REVISED RENDER STUDIES

CSMIA TERMINAL 2 - 05/02/2024

VISUALISING SUGGESTED CHANGES & METRIALITY MADE POST PRESENTATION APRIL 25TH, 2024

AMENITY SPACE - VIEW 3

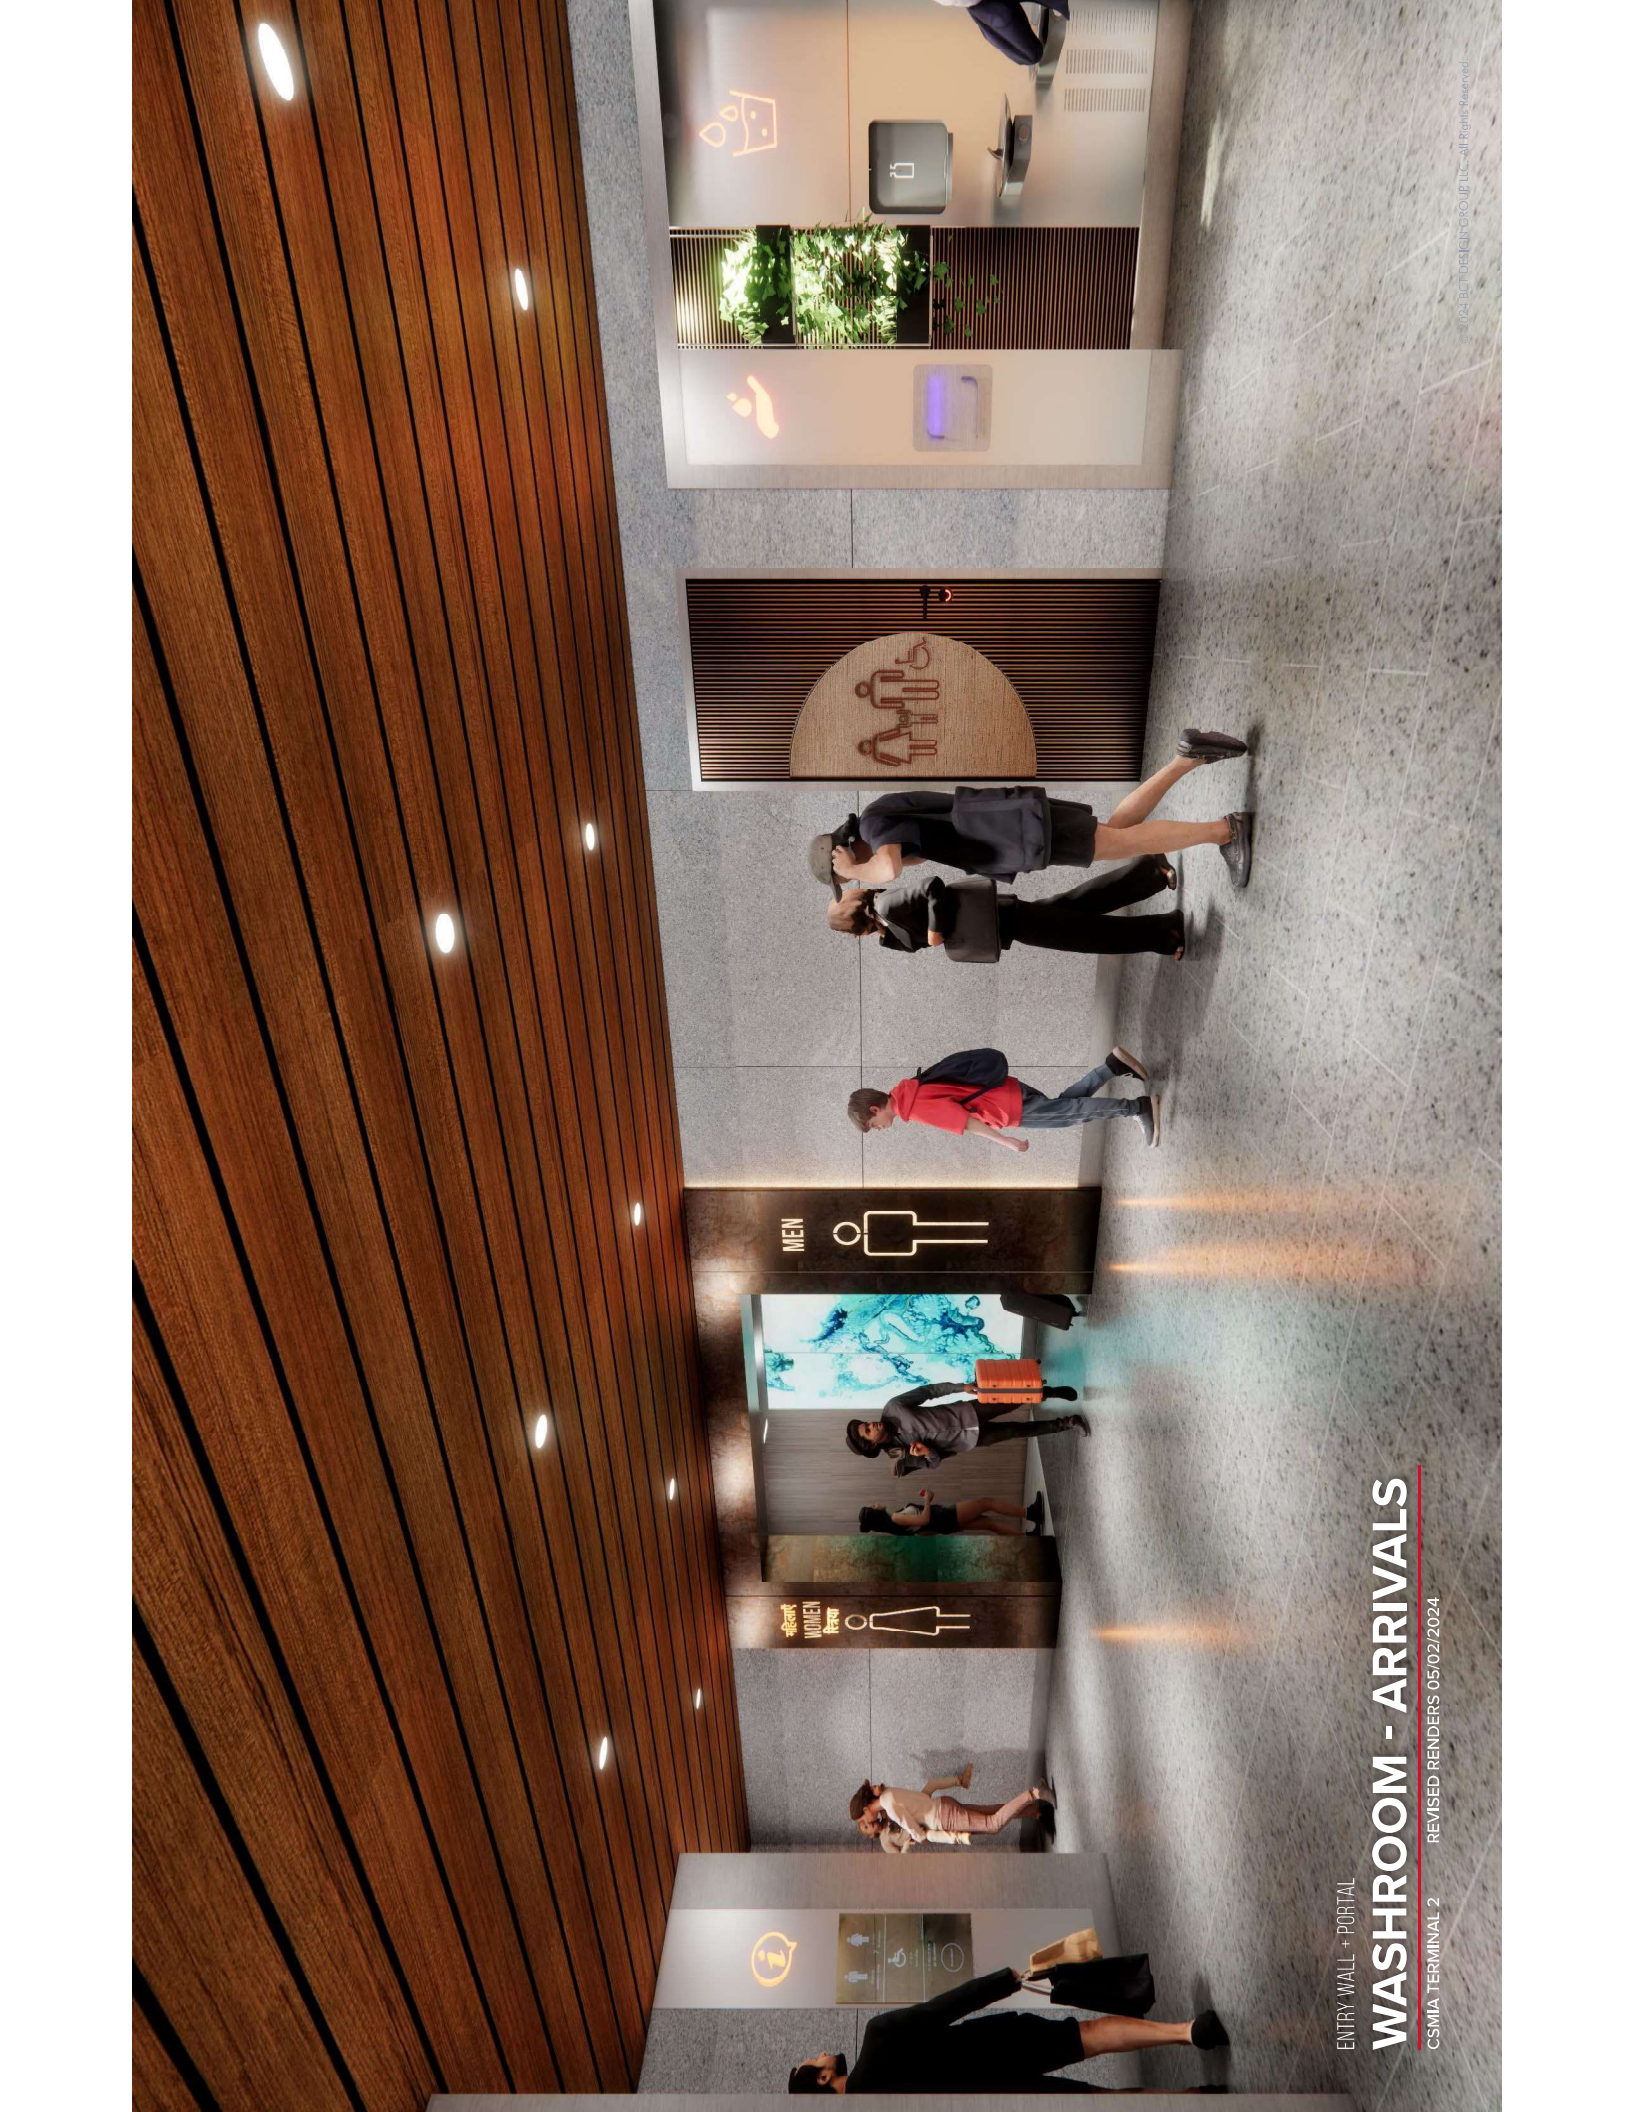
PROPOSAL FOR DECORATIVE SCREENS DESIGN W/
ROUNDED RHOMBUS SHAPES INDICATIVE OF THE
TERMINAL DECORATIVE PATTERNS. CONSIDER
PRIVACY GLASS INSERTS.
